**DOMUSEA DEVELOPMENTS
PROPOSED RESIDENTIAL ACCESS
ARRANGEMENTS - CLAYS FARM,
NORTH END ROAD, SUSSEX**

STAGE 1 - ROAD SAFETY AUDIT

JULY 2018

Project Code:	S/DDNorthendRoad.1.6
Prepared by:	Martyn Parr
Approved by:	John Reid
Issue Date:	July 2018
Status:	Final

APPENDIX B: Reference Plan

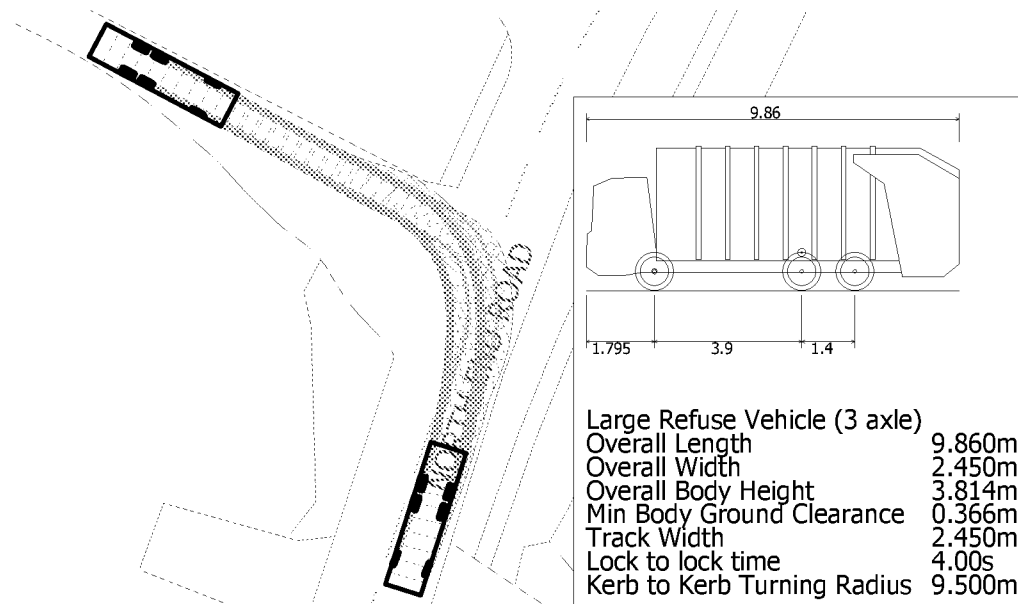
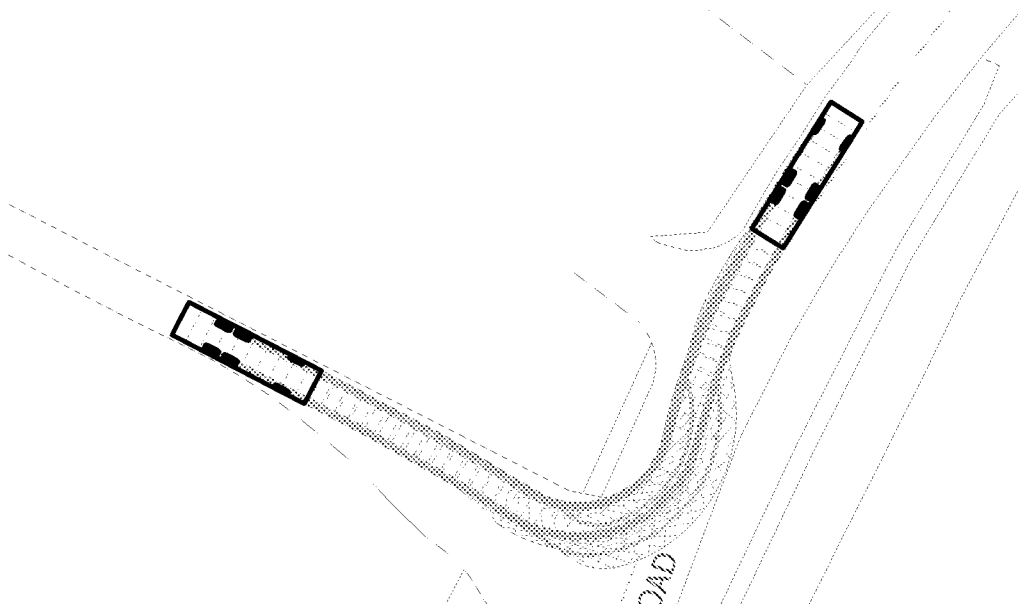
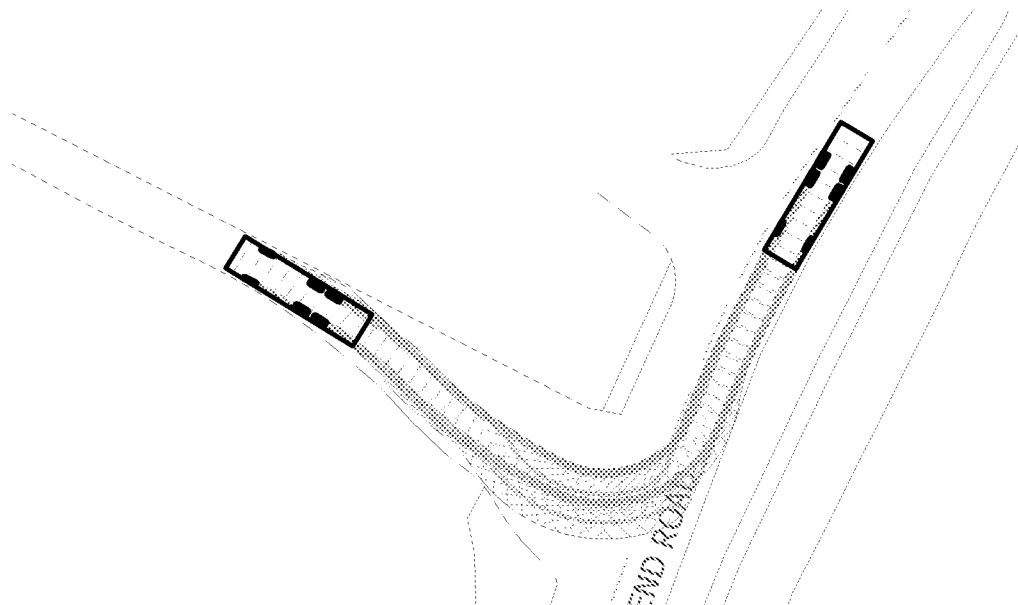
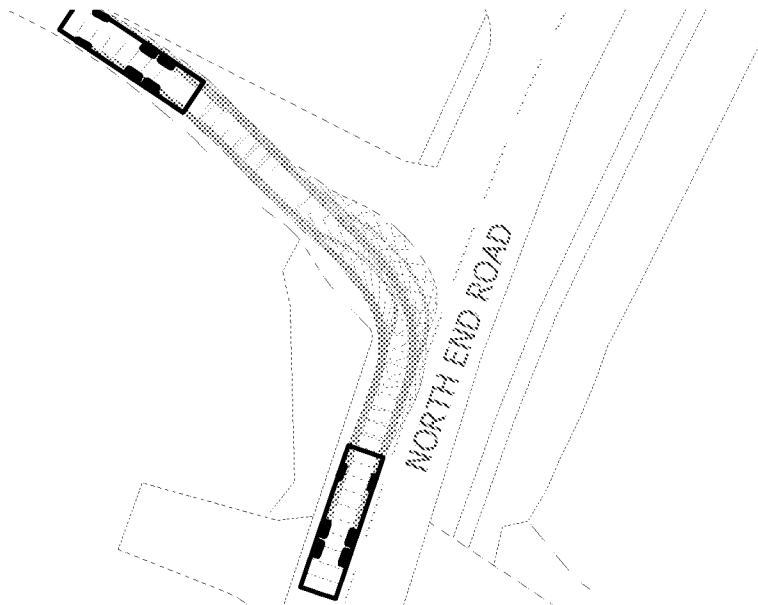
Location: Site access/North End Road (please refer to reference point 2.6 in **Appendix B**)

Summary: Insufficient pedestrian facilities

North End Road is provided with a footway on the eastern side only adjacent to the site access. Therefore pedestrians entering/leaving the development are likely to cross North End Road adjacent to the site access, rather than walk in the carriageway on the western side. For this reason it be important to ensure pedestrians leaving/entering the development site are able to cross North End Road safely and without trip hazards.

Provide sufficient footway on the western side of North Road to enable pedestrian to wait for a gap in the traffic to cross. So as to create a crossing point, this footway should be provided with dropped kerbs and tactile paving. Dropped kerbs and tactile paving should also be provided immediately opposite on the eastern side of North End Road, linking the crossing point to the existing footway.
